NEW NEC Requirement for Luminaire Disconnects

Disconnects shown actual size

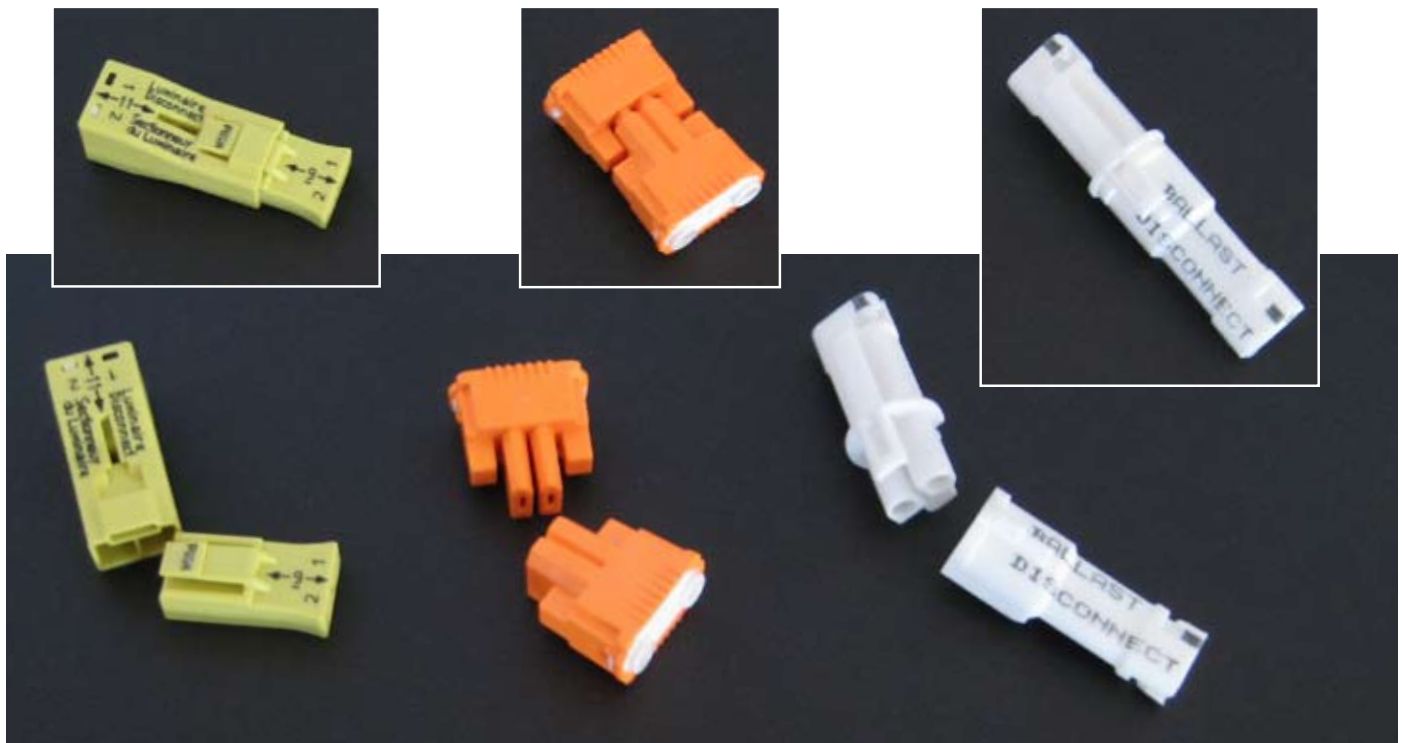
Litecontrol has identified several acceptable ballast disconnect devices now available from our vendors. Described simply, these devices consist of a polarized male-female plug set that is wired between the ballast and the branch circuit conductors supplying the fixture. Some examples of these devices are shown below.

In consideration of the additional burden placed on the electrical contractor by the new NEC requirement, Litecontrol is now installing ballast disconnect devices at our factory for all applicable fixtures that are shipped after January 1, 2008.
